This letter provides Five Estuaries Offshore Wind Farm Ltd's (VEOWFL) Deadline 6 representation to the Sea Link examination.

Non Concurrent working areas (RAM Vessels)

nationalgrid					
SEA LINK					
Document Title: NIP Concurrent RAM Activity Areas					
Creator: LM	Date: 09/04/2026	Checker: JL	Date:	Approver: RJ	Date:
Document Ref: FIGURE 9.12.2	Scale: 1:100,000	Format: A3	Sheets: 1	Rev: 3

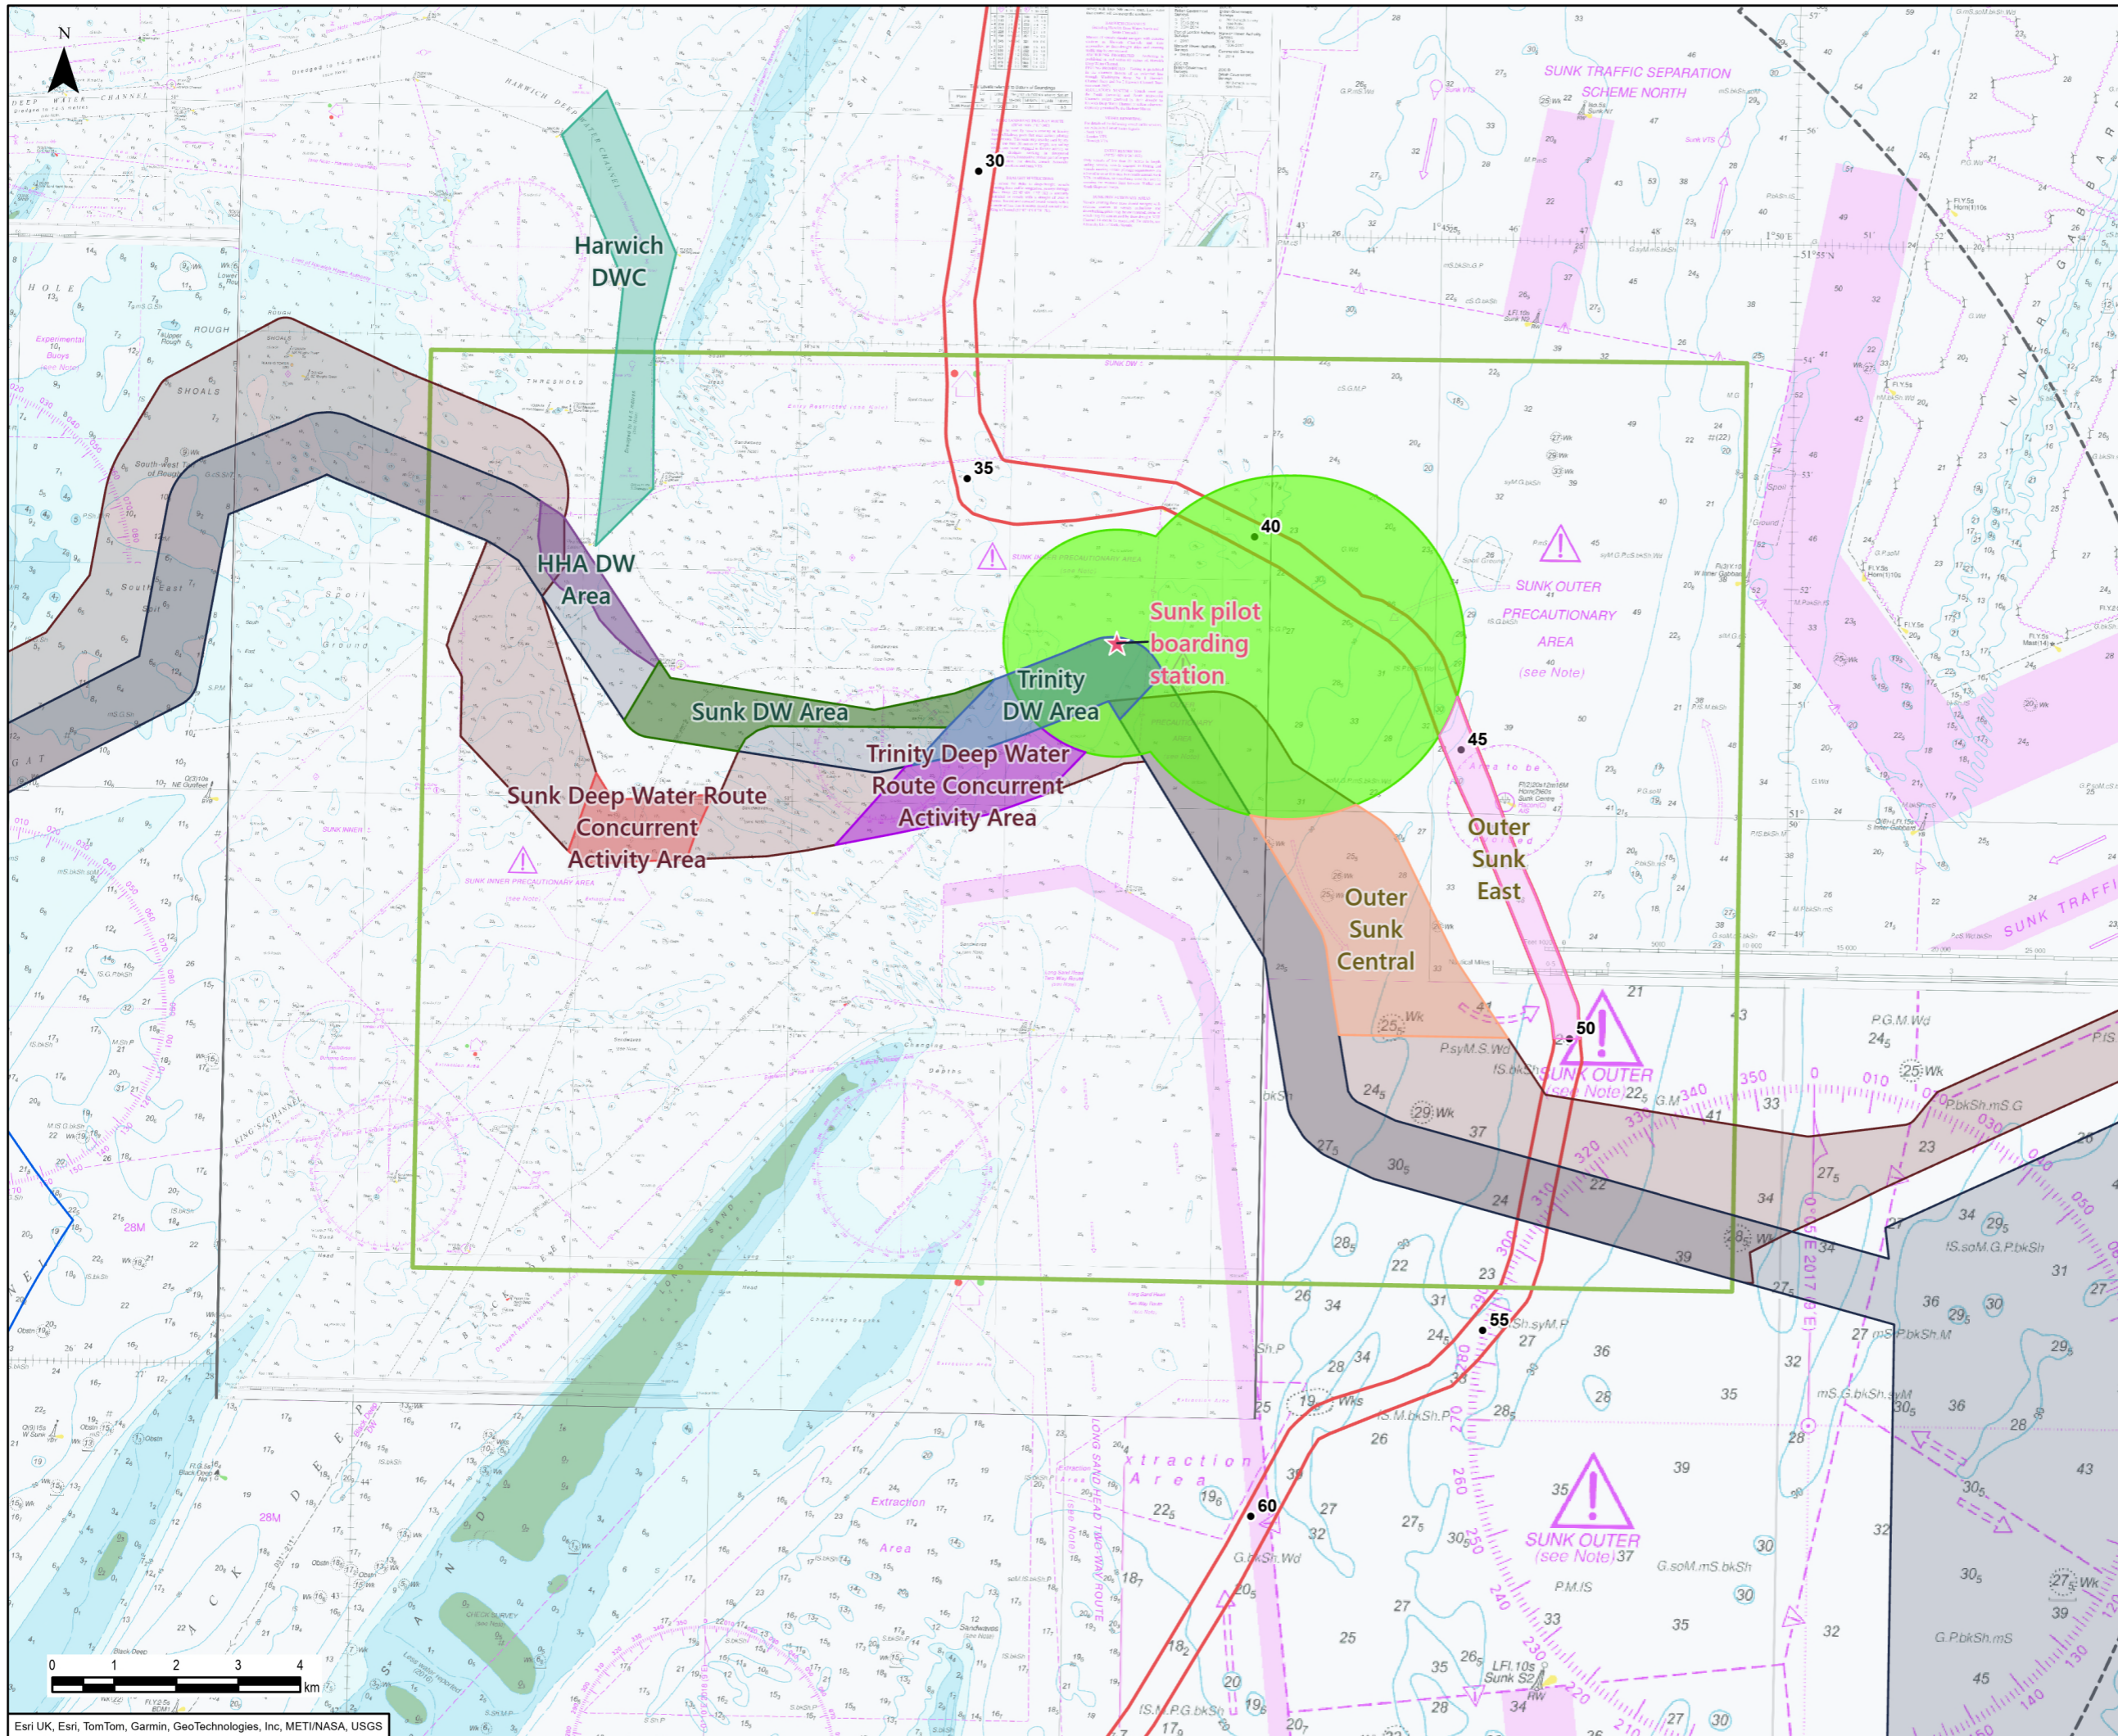
that would be a risk to maritime traffic. VEOWFL recognises the area Sea Link define in the drawing appended to this letter. VEOWFL is willing to co-ordinate with Sea Link to ensure that RAMs vessels for the two projects do not operate concurrently in the “Outer Sunk Central” and “Outer Sunk East” concurrent areas presented in the appended drawing.

Therefore, VE would be strongly opposed to increasing this area, to the proposed “Sealink_Simultaneous RAM&RV Stop Ops Area” shown in Fig.1 of REP4-163; particularly as it increases the extent of the VEOWFL consented cable corridor restricted in terms of concurrent activities. Whilst it is assumed that the proposed concurrent working area for RAM vessels would only apply to Sea Link vessels; this in itself would add further complexity to the co-ordination between the three Projects.
